SERVICE BULLETIN

M-1156 California Only

2004 VRSC AUXILIARY VOLUME REPLACEMENT PRODUCT PROGRAM P13

Figure 1. Remove Auxiliary Volume

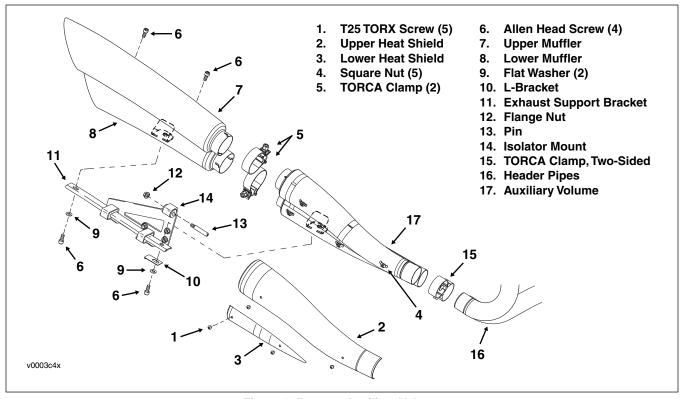
Harley-Davidson has recently learned that certain 2004 VRSC model motorcycles shipped to the state of California are equipped with an international (HDI) catalyst-containing auxiliary volume not intended for the California market. In the interest of customer satisfaction, Harley-Davidson has elected to replace the auxiliary volume on all affected motorcycles with the appropriate exhaust component.

- Remove right side cover and maxi-fuse. See Section 8.5 MAXI-FUSE, page 8-7 of the 2004 VRSC Models Service Manual (Part No. 99501-04).
- 2. Remove three T25 TORX screws to free upper heat shield from auxiliary volume. Remove two screws to release lower heat shield. See Figure 1.

- Slide new two-sided TORCA clamp onto pipes at front of new auxiliary volume. Orient clamp so that nut is at the bottom facing the outboard side. Push and wiggle auxiliary volume onto front and rear header pipes.
- Place 1/2 inch spacer between bottom of auxiliary volume and top of lower frame tube to gauge approximate position of assembly.
- Align flange on inboard side of auxiliary volume with isolator mount on exhaust support bracket. Slide threaded end of pin through isolator mount and flange.
- Apply a small dab of Loctite Medium Strength Threadlocker 243 (blue) to threads of pin. Install flange nut and tighten to 23 Nm (17 ft-lbs). If necessary, insert punch through hole in pin and hold to prevent rotation.
